The Commission has issued the enclosed Amendment Nos. 121, 116 and 92 to Facility Operating License Nos. DPR-33, DPR-52 and DPR-68 for the Browns Ferry Nuclear Plant, Units 1, 2 and 3. These amendments are in response to your application dated September 22, 1983 (TVA BFNP TS 191), as supplemented March 20, 1985.

These amendments revise the present pressure-temperature limit curves (Figure 3.6-1) in the Technical Specifications to provide more conservative limiting temperatures for pressure test, heatup, cooldown and core operations which are valid for 12 equivalent full power years of plant operation. On April 12, 1985, we had issued Amendment No. 87 for Browns Ferry Unit 3 which, as an interim measure, had approved the same identical curves for the duration of the present Cycle 6 operations.

SAFETY EVALUATION BY THE OFFICE OF NUCLEAR REACTOR REGULATION

BROWNS FERRY NUCLEAR PLANT, UNITS 1, 2 AND 3

Figure 3.6-1

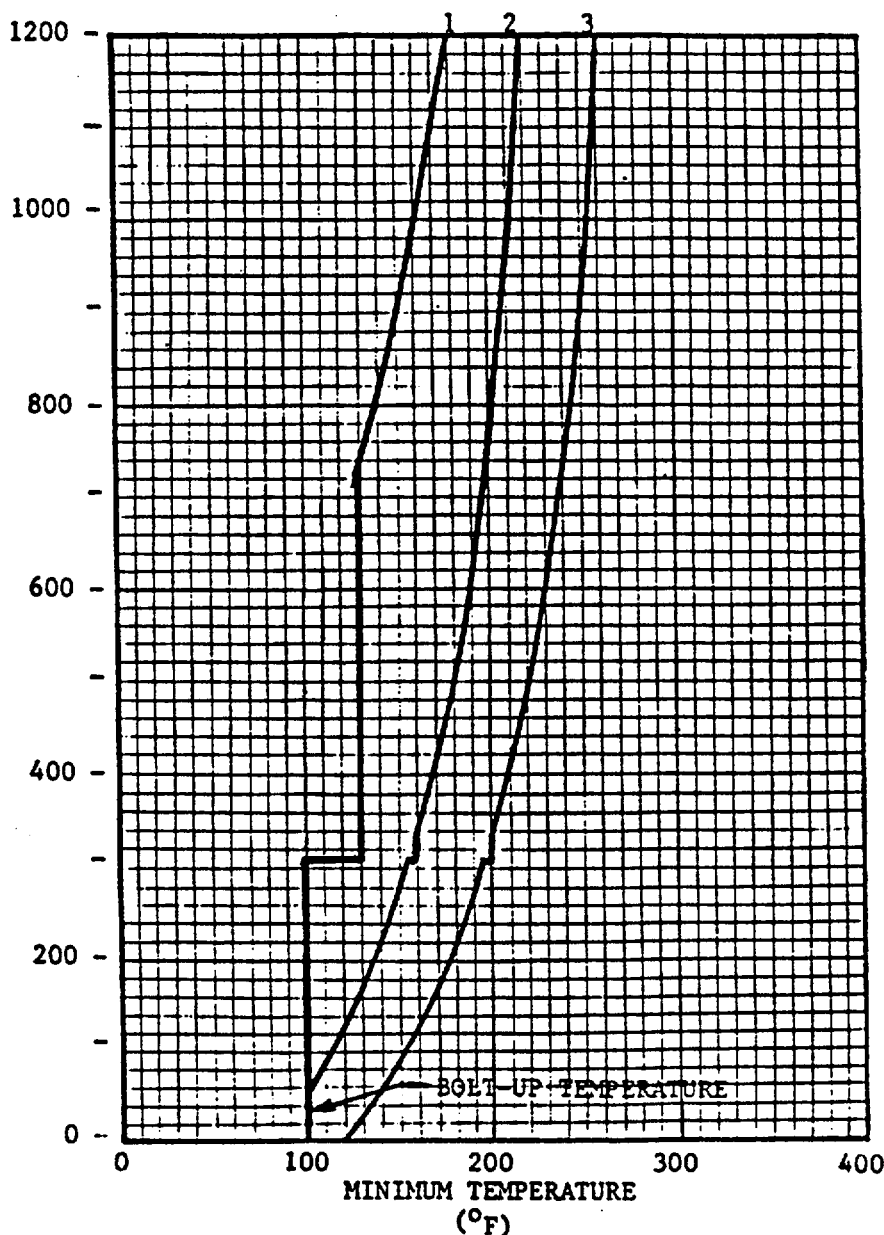
These curves include sufficient margin to provide protection against feedwater nozzle degradation. The curves allow for shifts in RTNDT of the reactor vessel beltline materials to compensate for radiation embrittlement for 12 EFY.

Figure 3.6-1

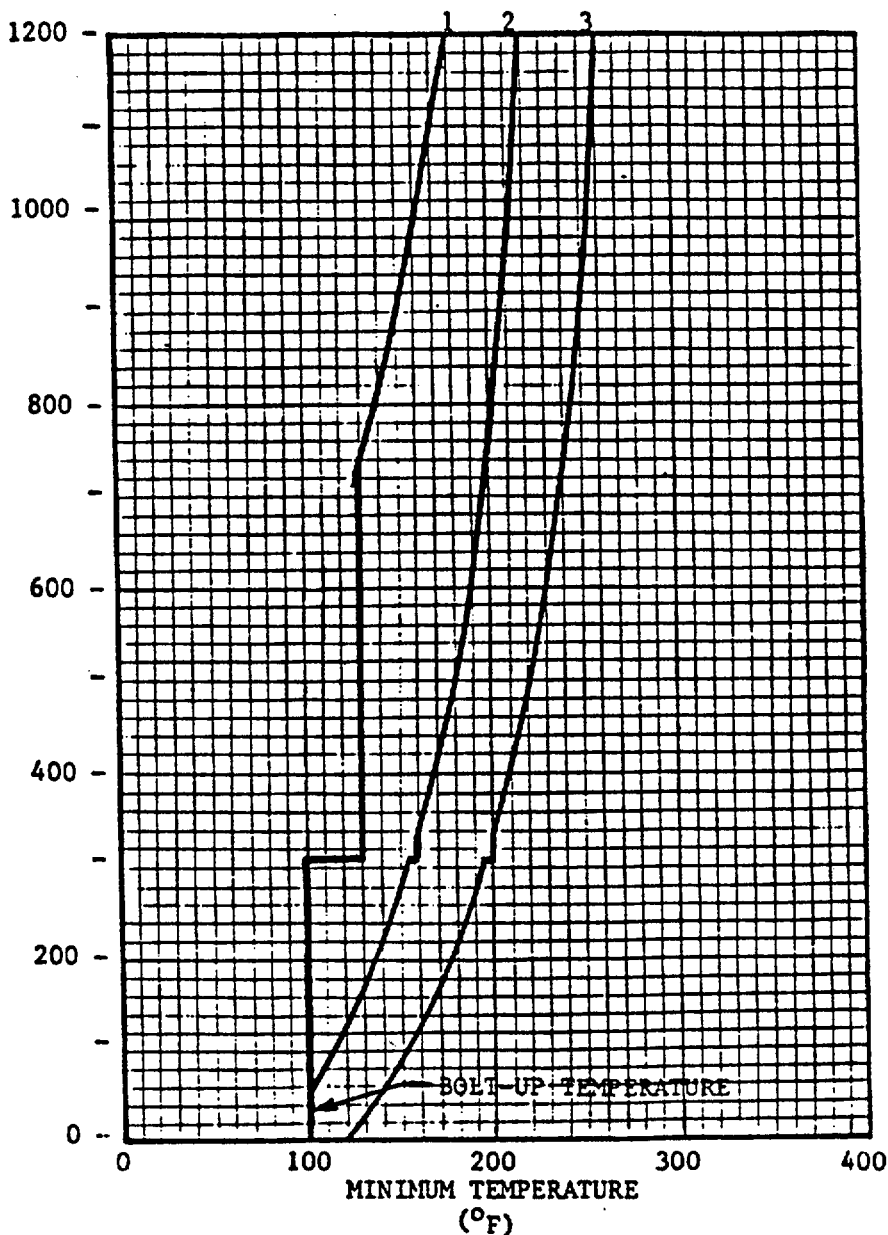
These curves include sufficient margin to provide protection against feedwater nozzle degradation. The curves allow for shifts in RTNDT of the reactor vessel beltline materials to compensate for radiation embrittlement for 12 EFPY.

Figure 3.6-1

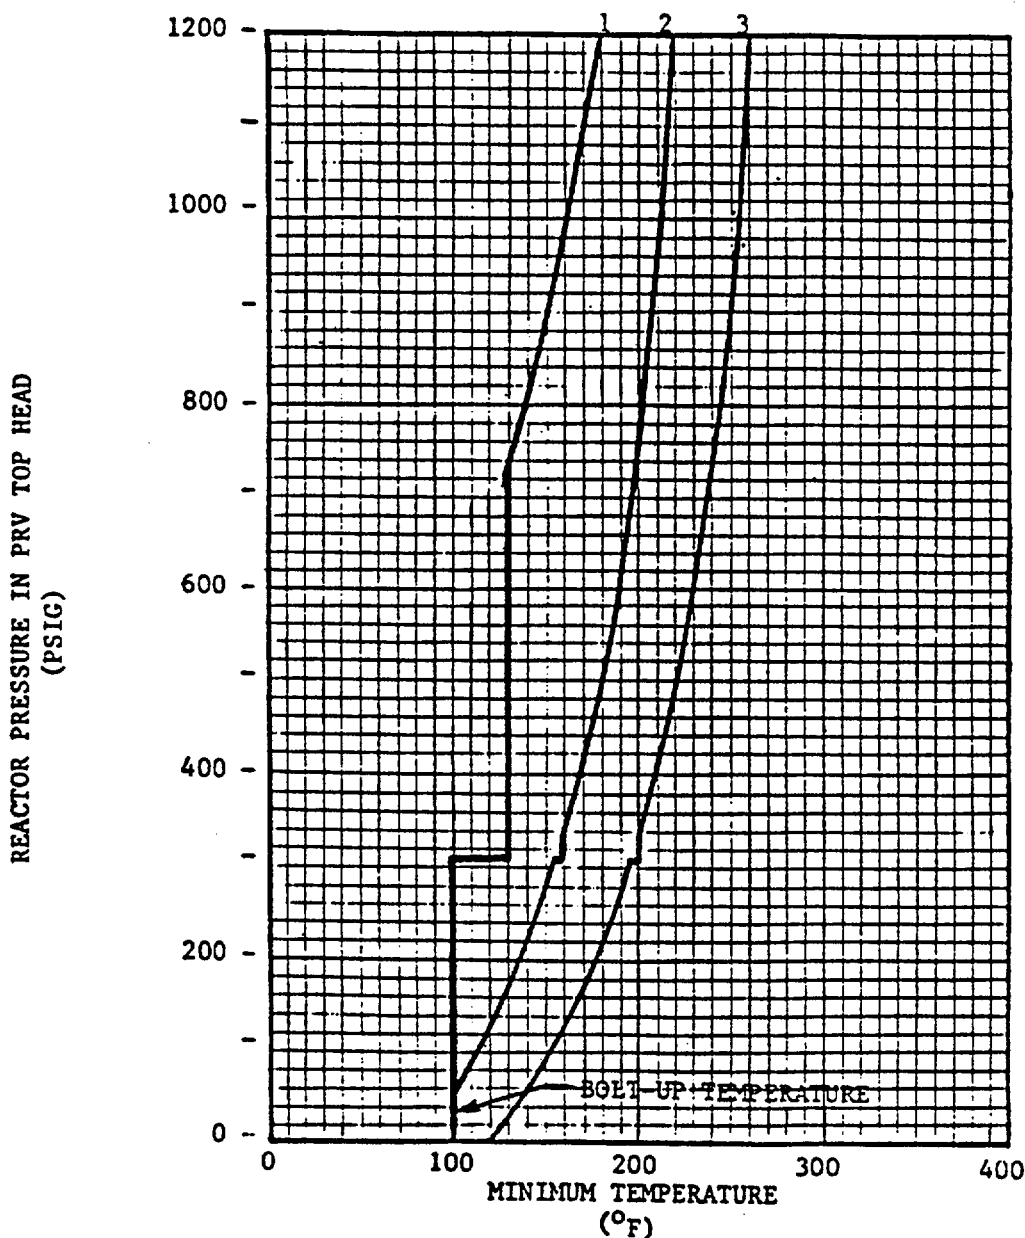
Notes
These curves include sufficient margin to provide protection against feedwater nozzle degradation. The curves allow for shifts in RTNDT of the reactor vessel beltline materials to compensate for radiation embrittlement for 12 EFPY.
